ADDENDUM NO. 1

PROJECT: Upper Red Rock Lake Winter Grayling Habitat Project

FWP PROJECT #: 23-07

DATE: 7/26/2023

ACCESS ROAD SUBGRADE PROTECTION SPECIFICATION

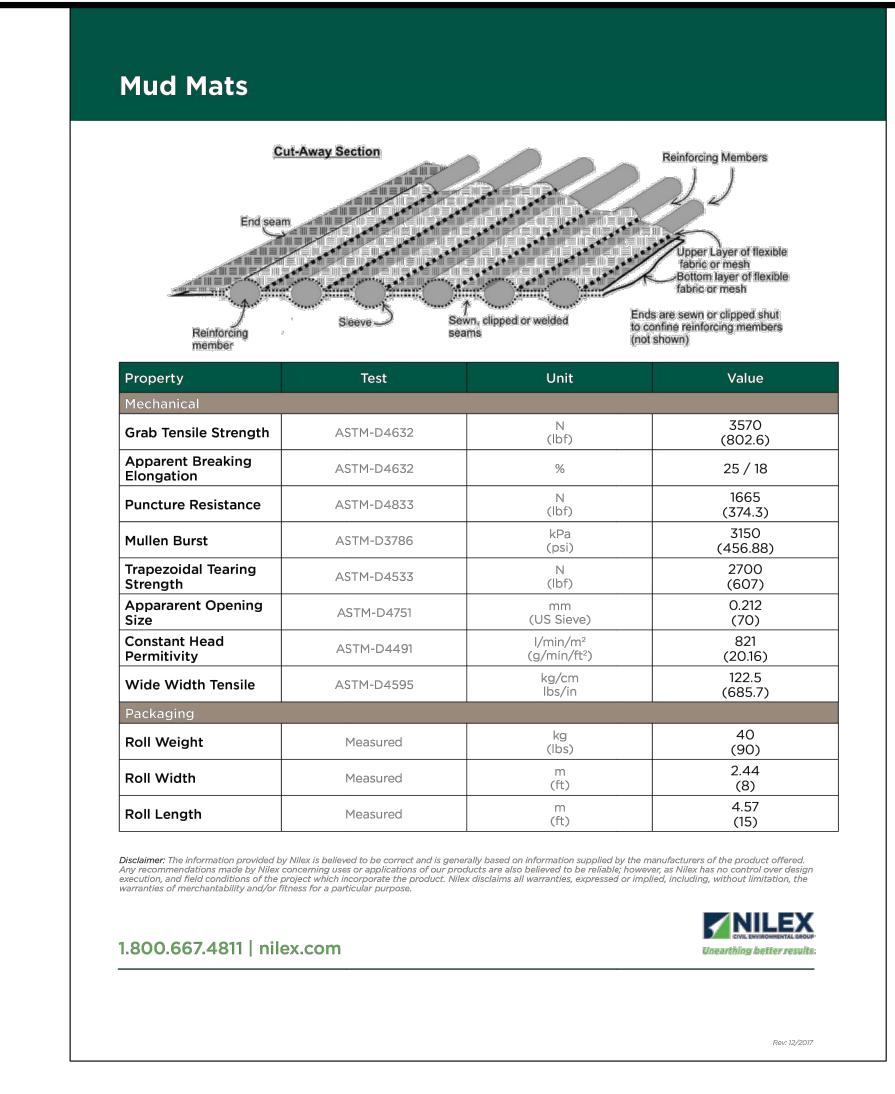
- 1. Do we need to install base course under the LPCA?
 - a. Yes. The plans have been updated to require a 6" thick layer of 1-1/2" base coarse. The base course will be installed on a 6-oz. non-woven geotextile fabric in direct contact with the prepared subgrade.

CLEANOUT TRACER WIRE DETAIL - PROFILE VIEW

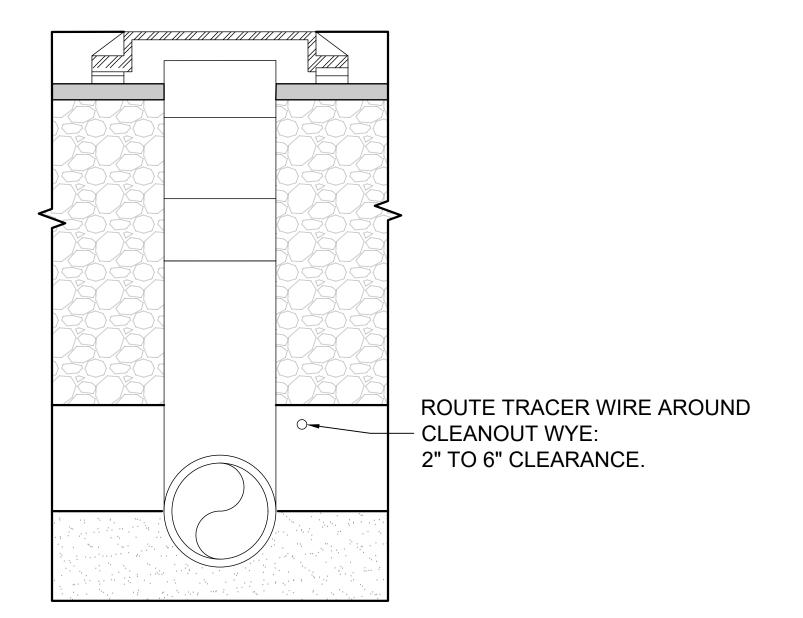
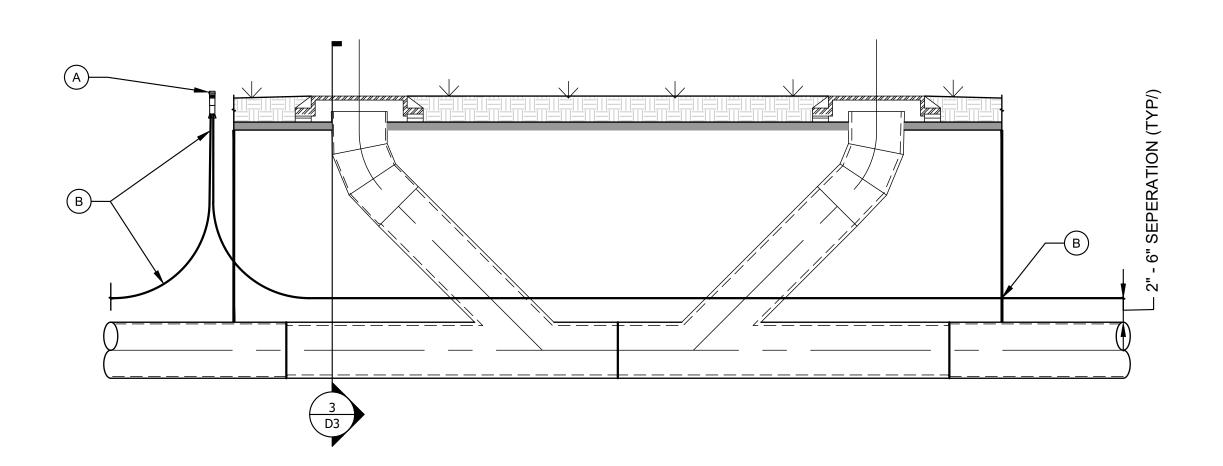
- a. The callout should read HDPE Flange Adapter and not Fabricated Tee.
- 7. Will any coating be required for the manhole covers over the cleanouts, or is standard bare metal acceptable?

- a. Standard cast iron manhole covers are acceptable.
